AGENDA PORTLAND PLANNING BOARD MEETING

Memorandum Planning and Urban Development Department

To: Brandon Mazer, Chair and Members of the Portland Planning Board
From: Andrew Tufts, Planner
Date: February 5, 2021
Re: 100 BLDG F West Commercial Street (Canal Landing Phase V)
Project #: PL-001220-2020
Meeting: February 9, 2021
CBL: o6o Foo3

Subject: Canal Landing New Yard – Phase V (Building F)
100 West Commercial Street
Level III Preliminary Site Plan Application
Applicant: New Yard, LLC

Drawing No.
C-3.2

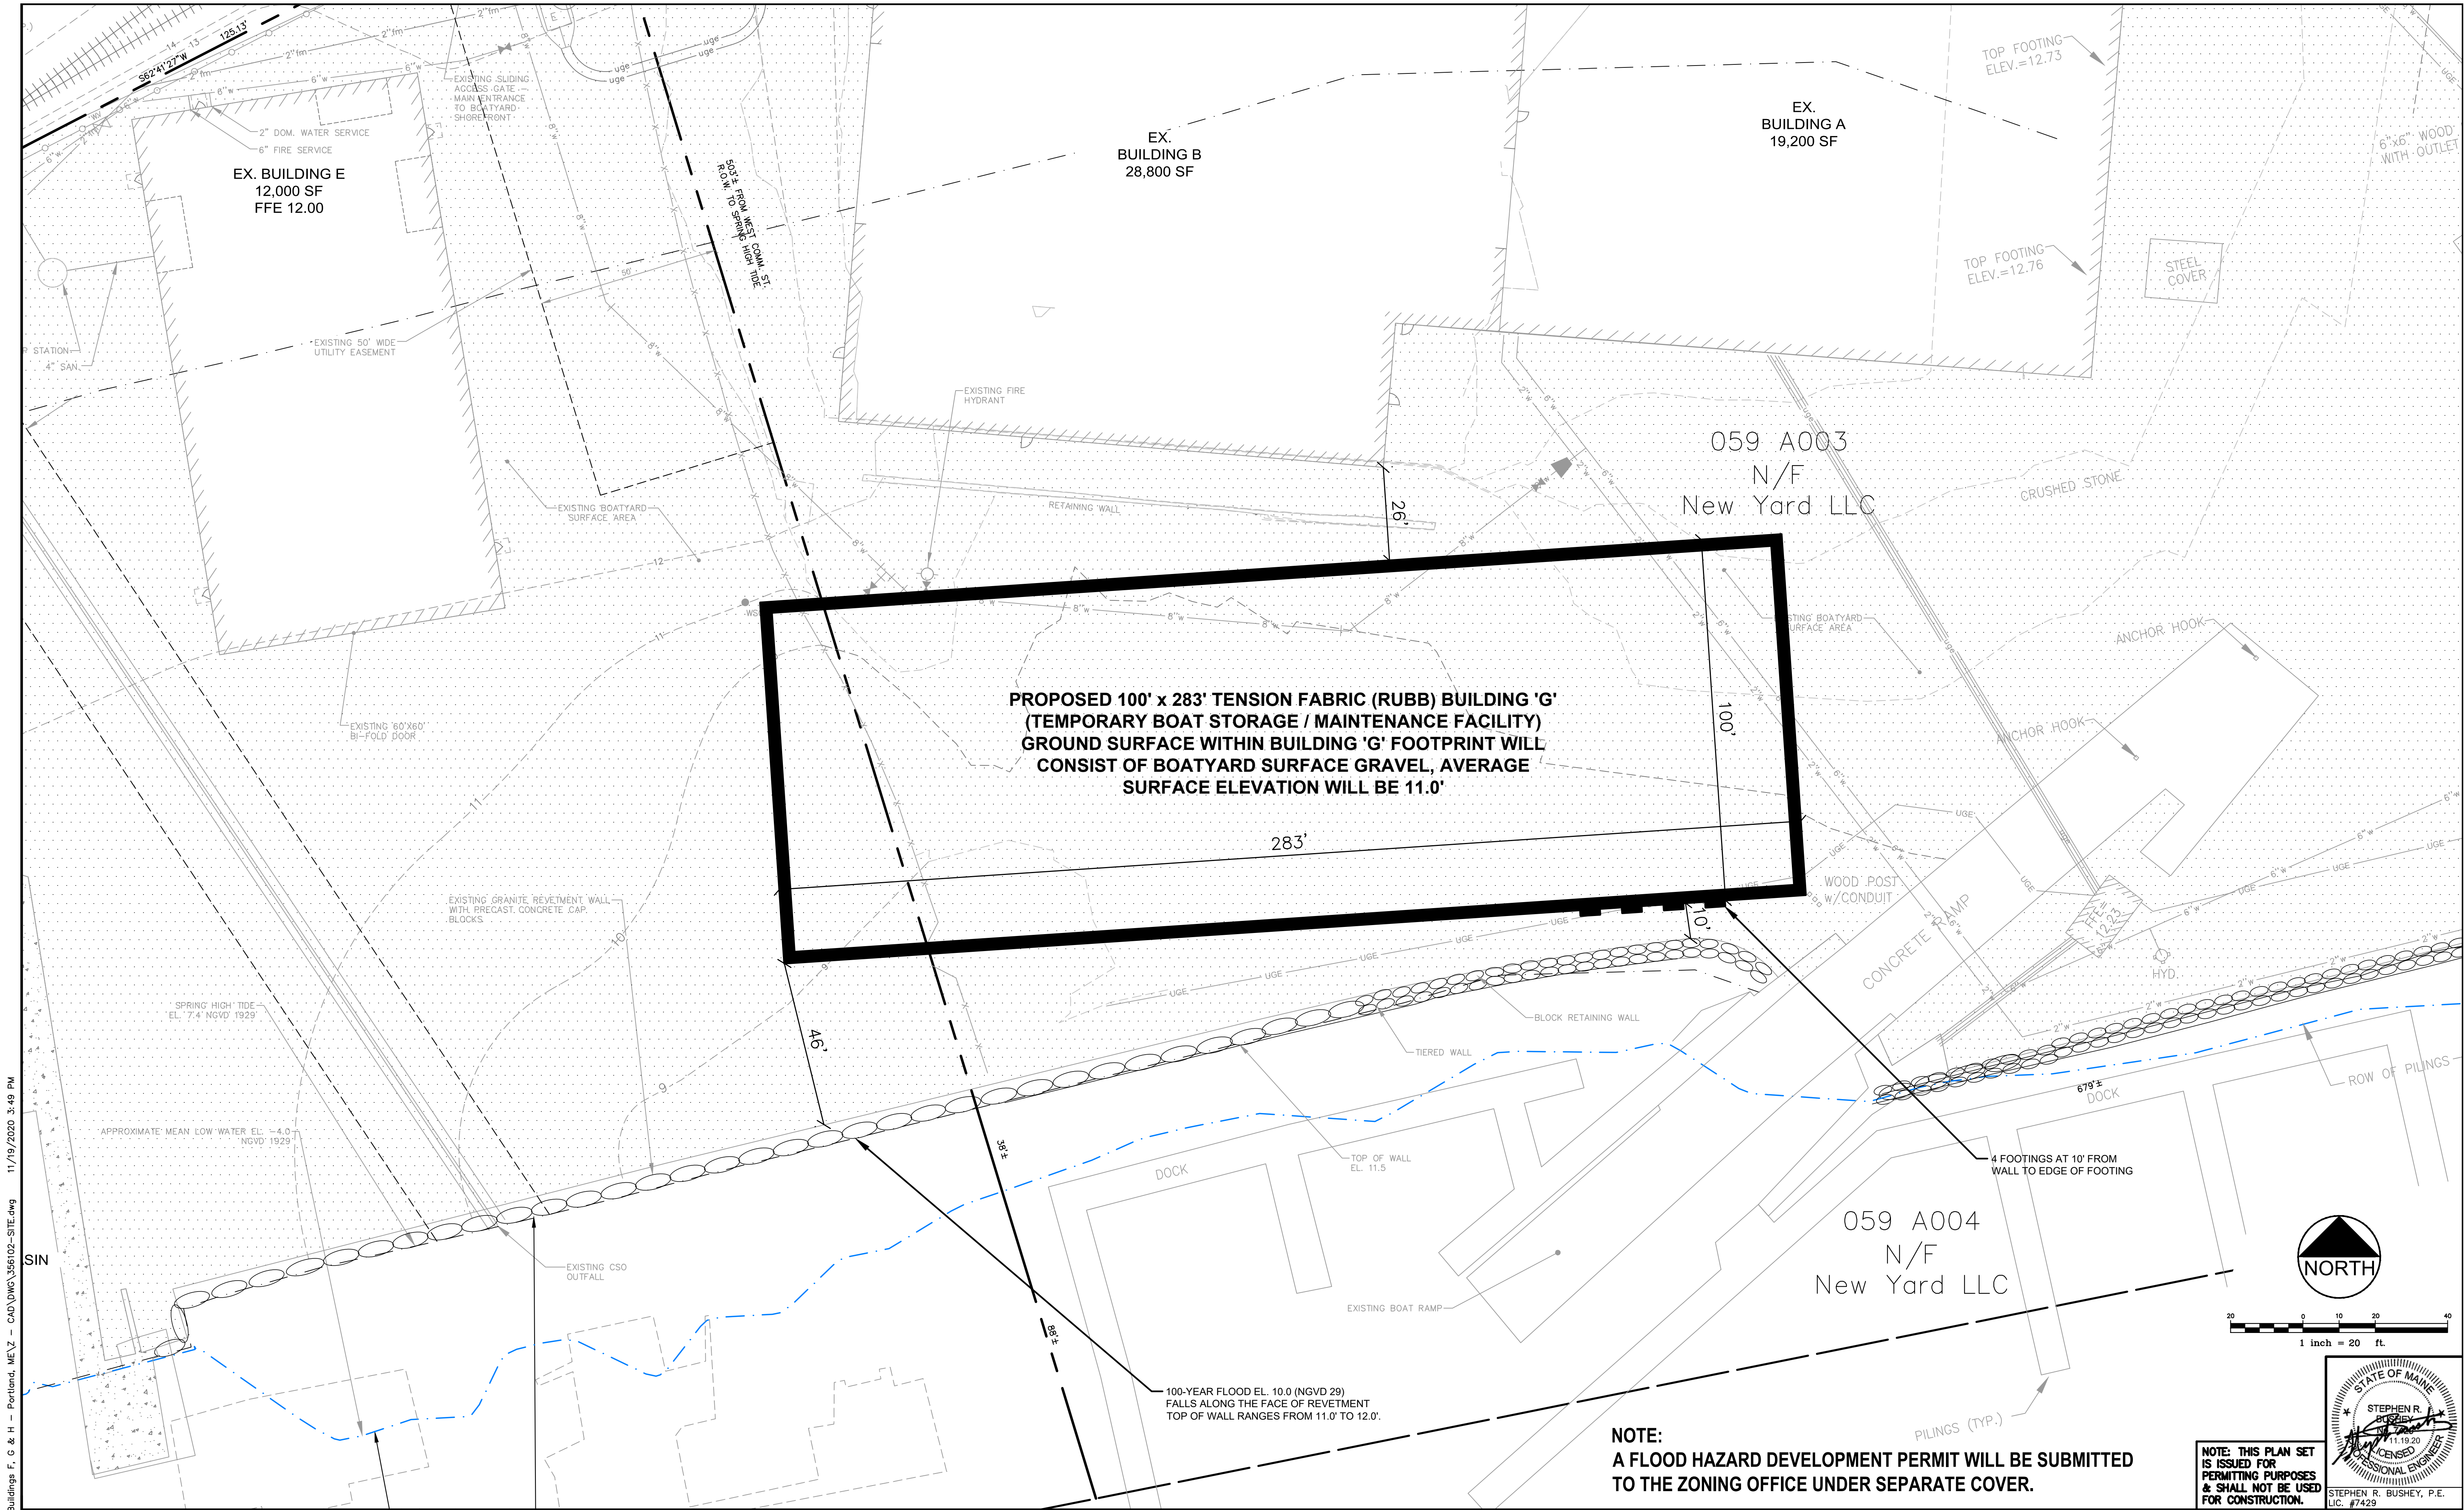
Circulation flow on plans appears to be one-way only; in the existing condition, the site is using the same entrance for both ingress and egress, this needs to be reconciled somehow.

Prepared For:		Owner	
		Address City, State	
Consultant:		Architect:	
		ARCHETYPE architects 48 Union Wharf Portland, Maine 04101 (207) 772-6022 ARCHETYPE@ARCHETYPEPA.COM	
Project:		CANAL LANDING BUILDING F	
		PORTLAND MAINE	
Revisions:		Date: 7/28/2020	
		Scale: 1/8" = 1'-0"	
		FLOOR PLANS	
		A1.01

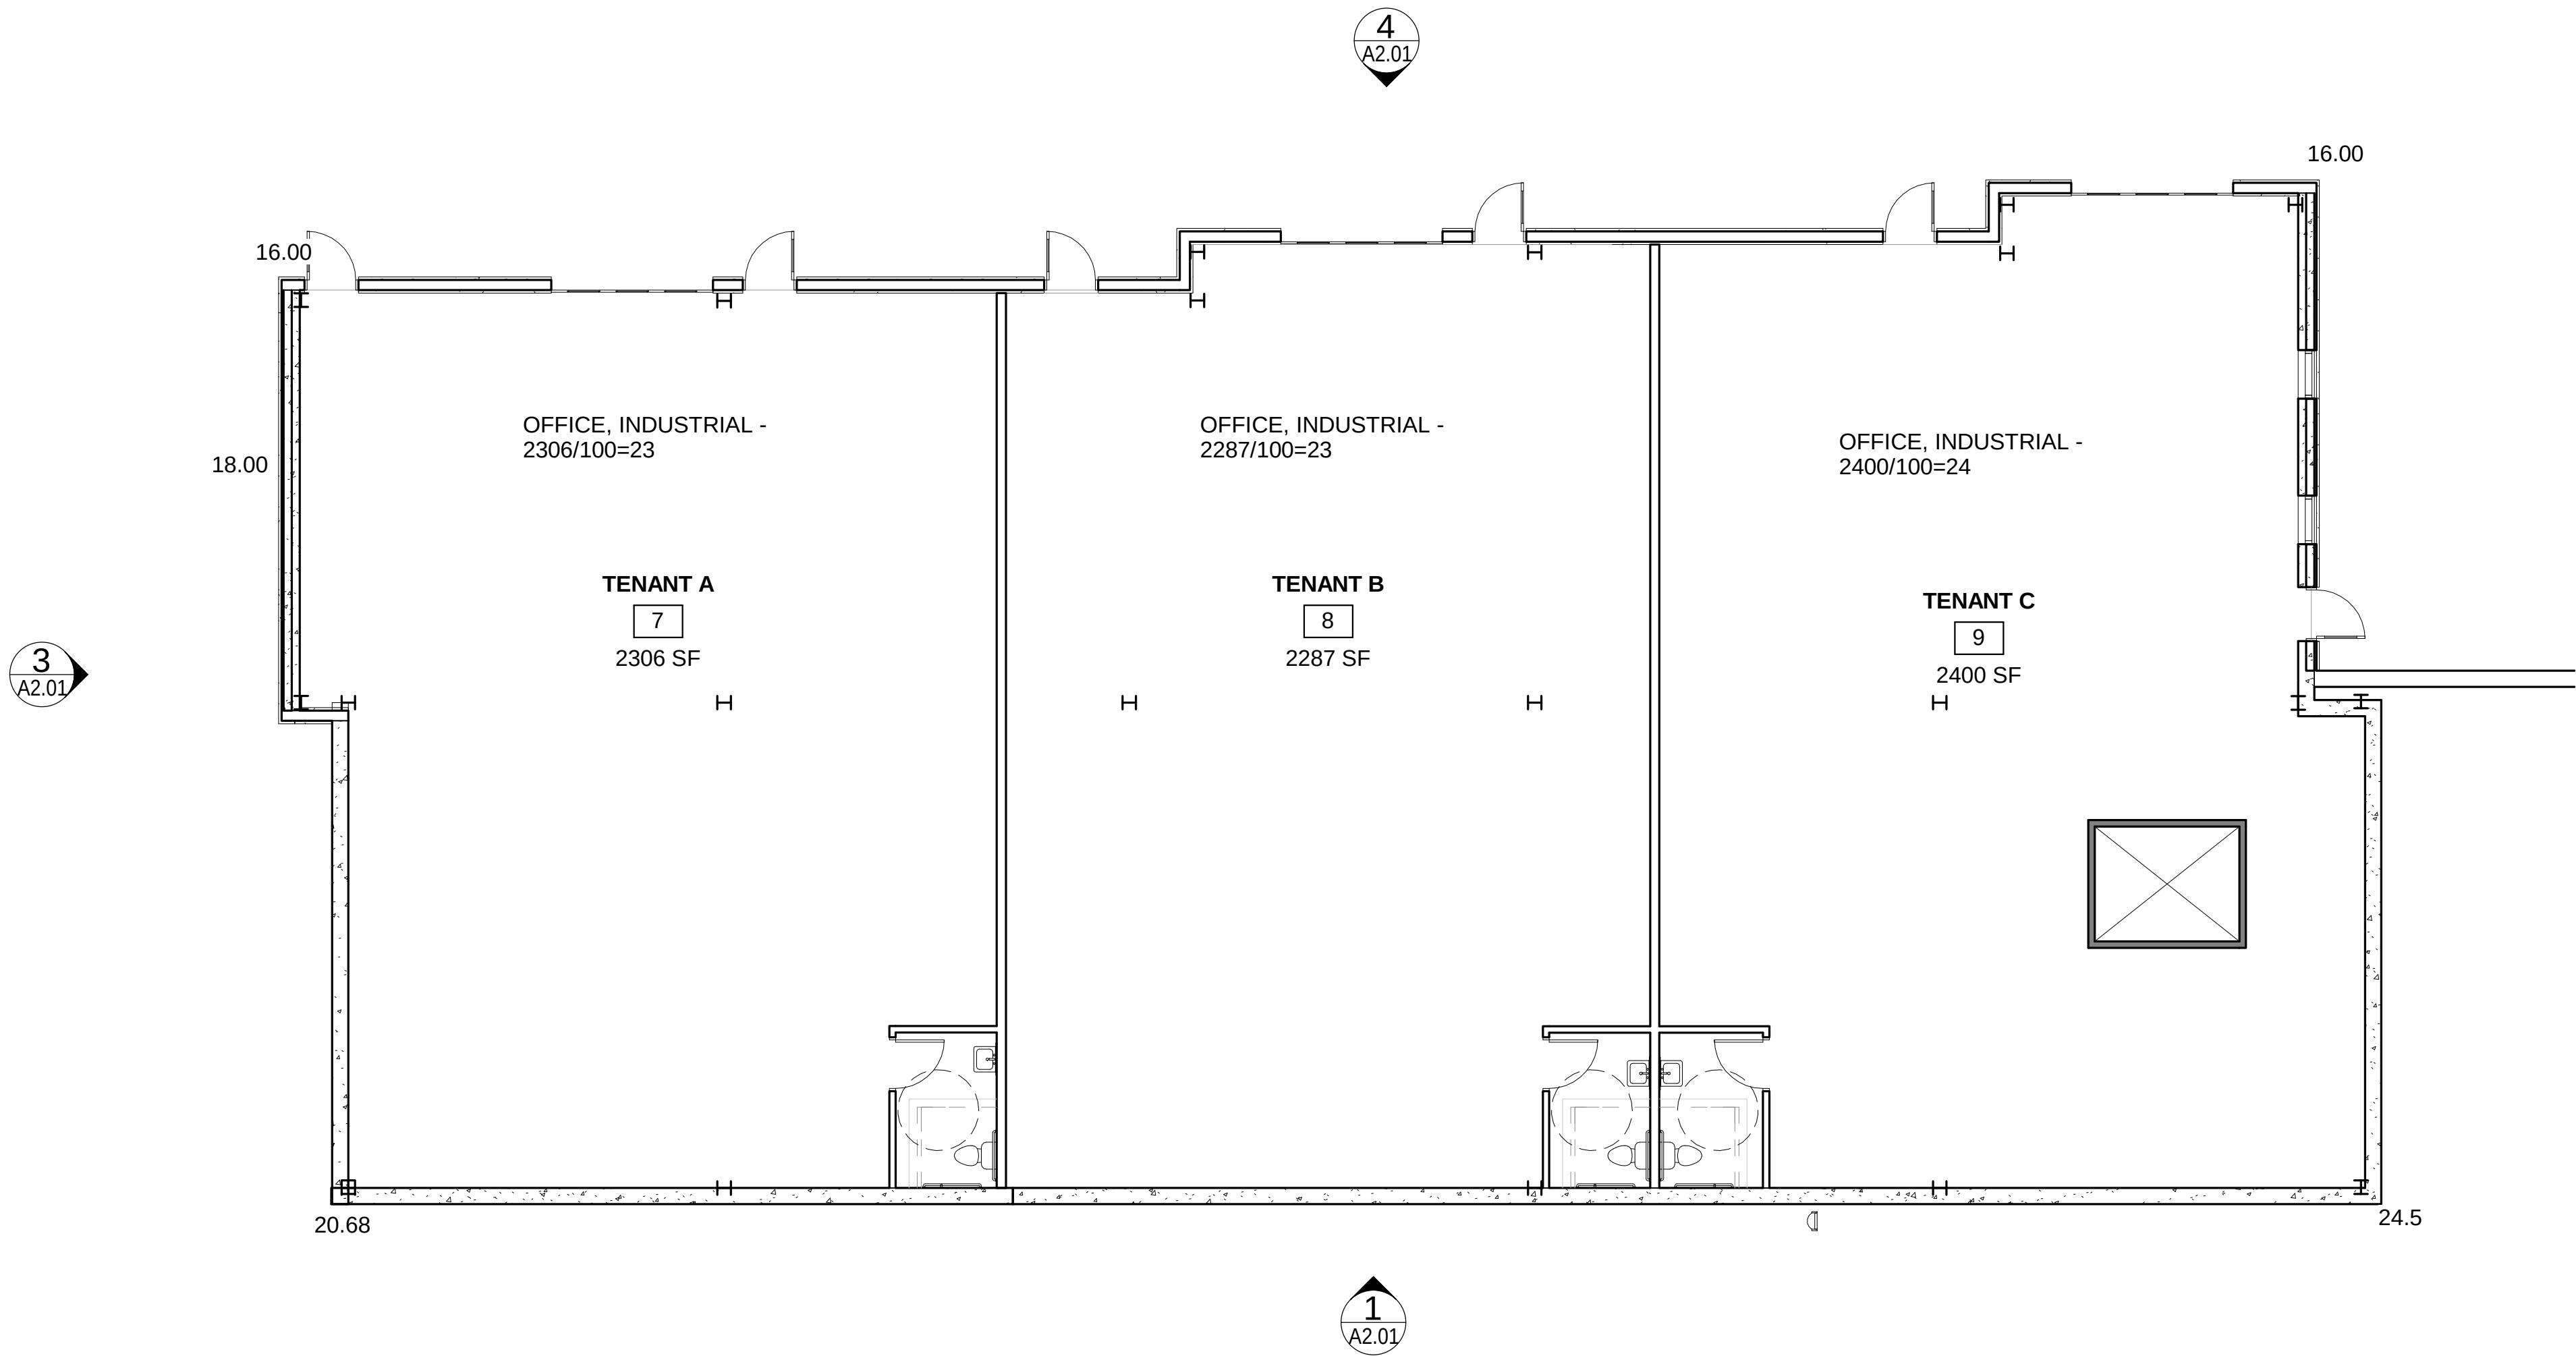
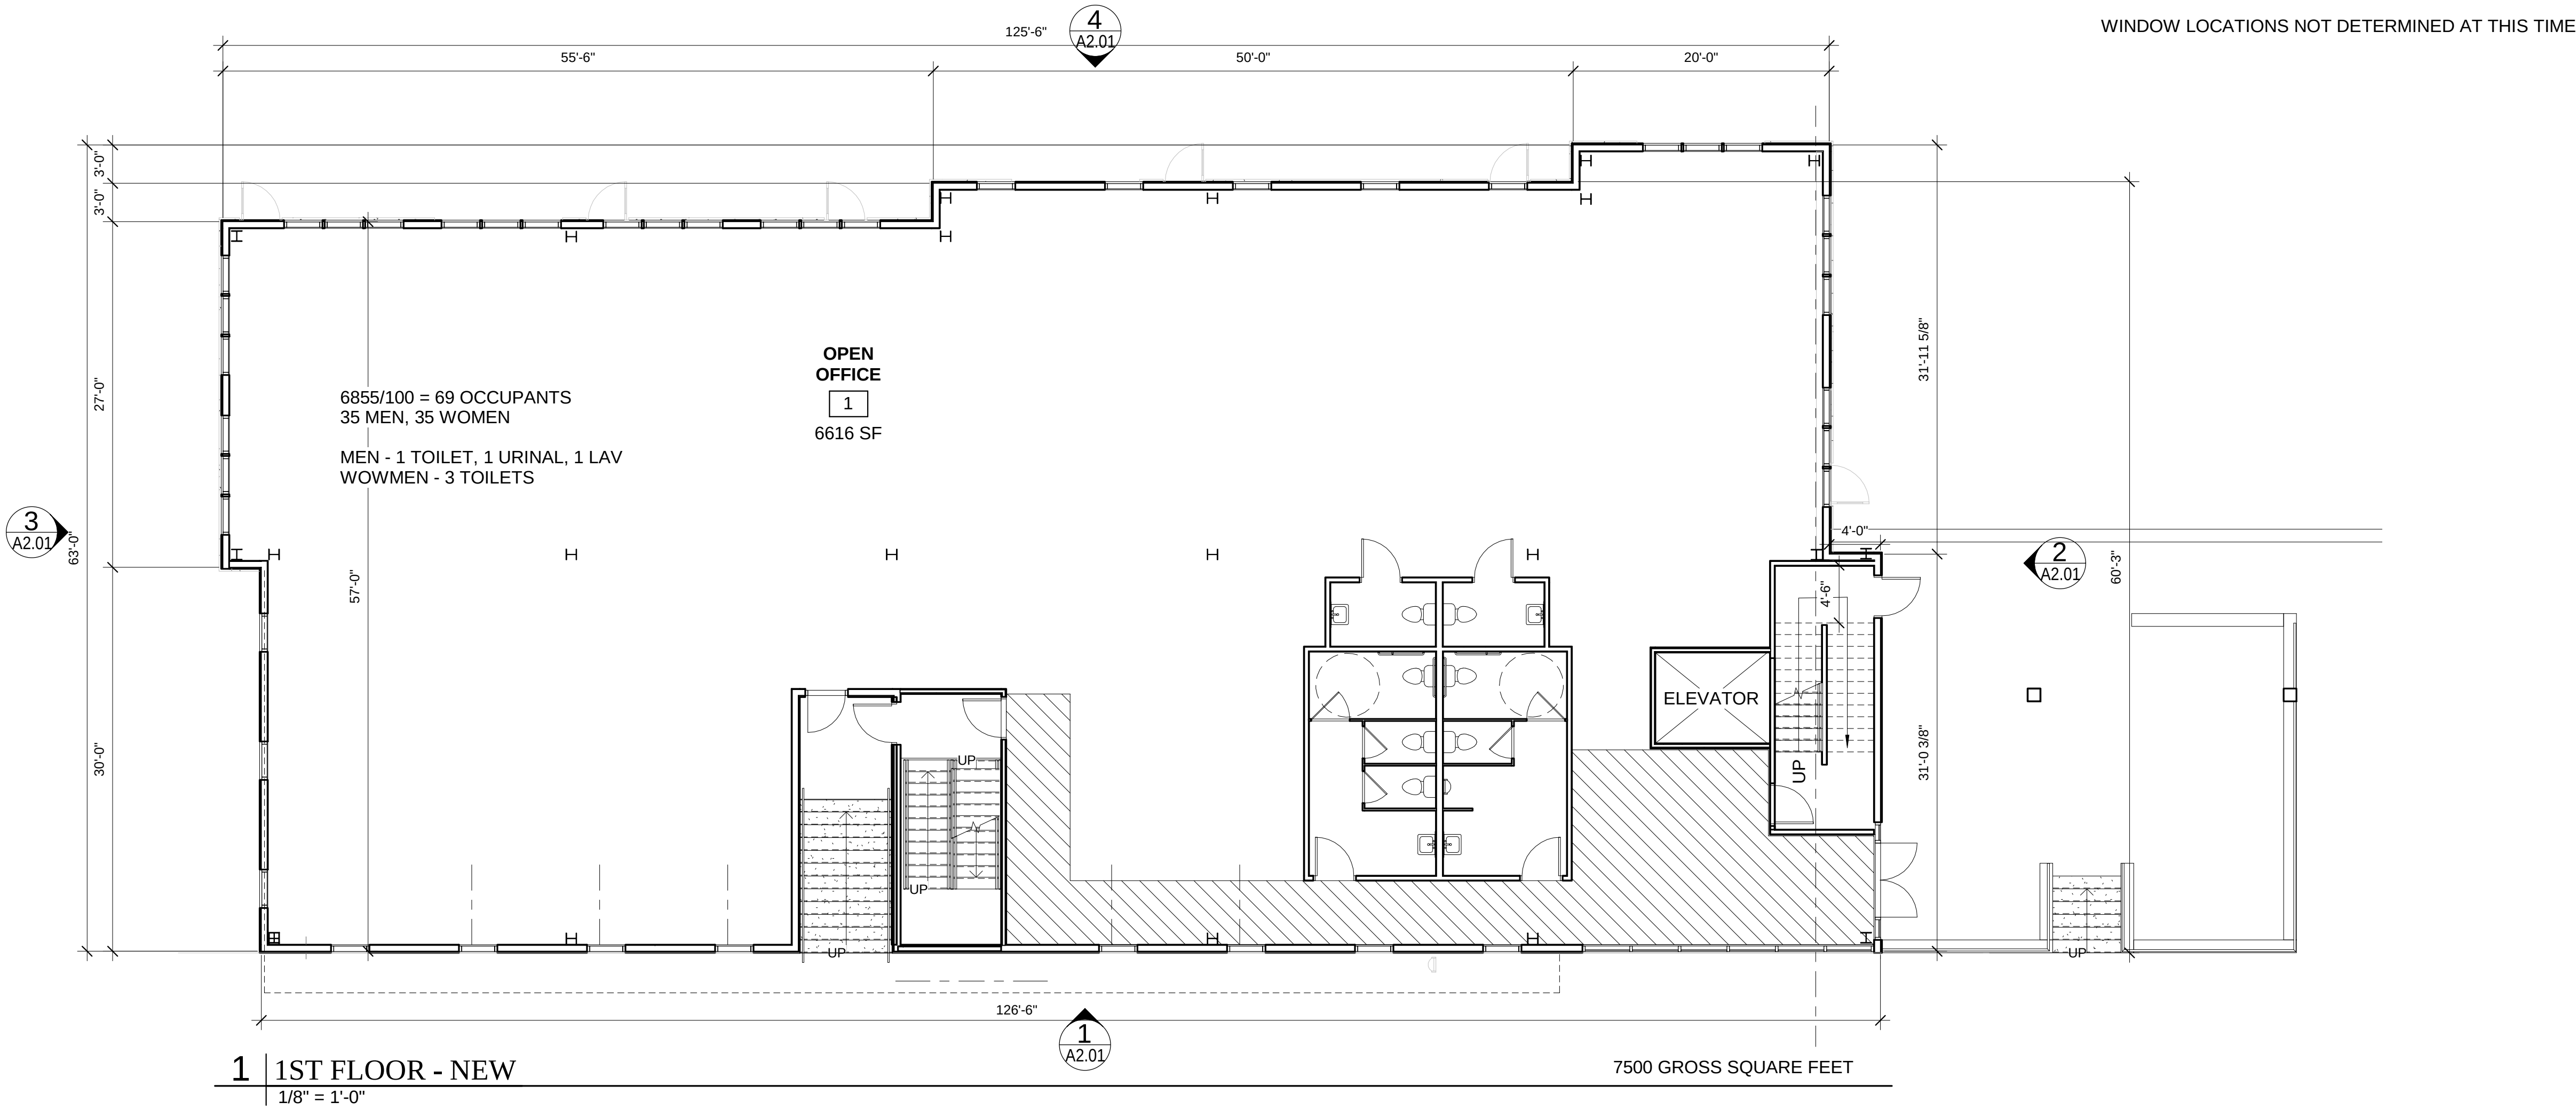
- 4. The basement plan, sheet A1.00 divides the space up into 3 tenants. The use is labeled office, industrial. Office is not a permitted use in the zone and industrial is pretty vague. Can you ask them if they have specific tenants in mind?*
